3. COA-062063-2019

420 North 26th Street

Commission of Architectural Review

STAFF REPORT

Figure 5. 1905 Sanborn map

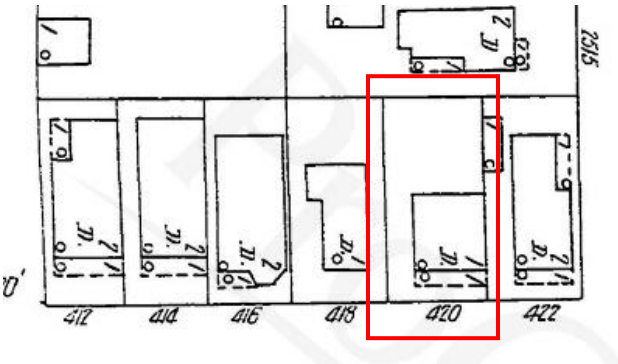
The applicant proposes to demolish a ca. 1968 14x16 feet (224 SF) addition on the building. Staff believes the addition does not contribute to the overall historic character of the building or of the surrounding district. Staff also finds the addition detracts from the historic form of the building, which was originally rectangular. Staff recommends approval of the request to demolish the side addition.

Staff finds the demolition of the side addition and the construction of a rear addition will convert the building from an L-shape to a mostly rectangular building. Staff finds a rectangular building is more in keeping with the original shape of the building and those found in the surrounding area.
